SIB 52 01 23

2023-02-23

## RECALL 23V-039: SIDE AIR BAG COVER (REAR SEATS)

This Service Information Bulletin (Revision 2) replaces SI B52 01 23 **dated February 2023.**

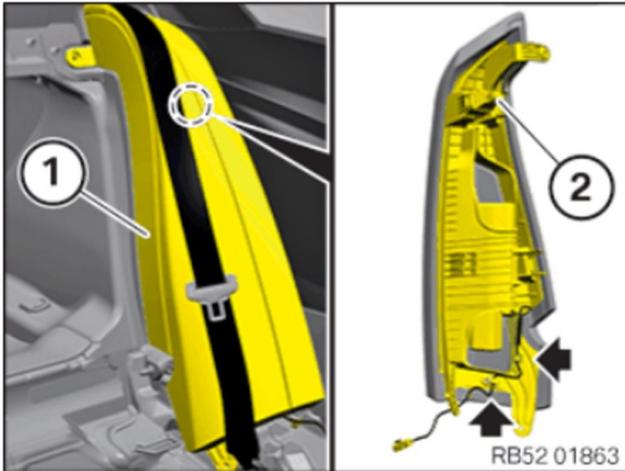
The side air bag cover panel on the rear seats may not have been produced to specifications by the supplier. In certain crashes where side air bag deployment is warranted, the cover panel may crack. If this happens, then the side air bag may not deploy as intended, which could increase the risk of injury.

Supplier backrest side panel material does not meet design criteria.

Replace both rear seat backrest side panels which contain the air bag.

Replace the rear seat backrest side panels (left and right; circled) in accordance with repair instructions 52 26 008 (backrest side panel at the rear seat back).

Unclip and remove the backrest side panel section (1) on the rear seat backrest from the clamp (2).

Check the clamp (2) for damage. A replacement clamp should be present on the new part.
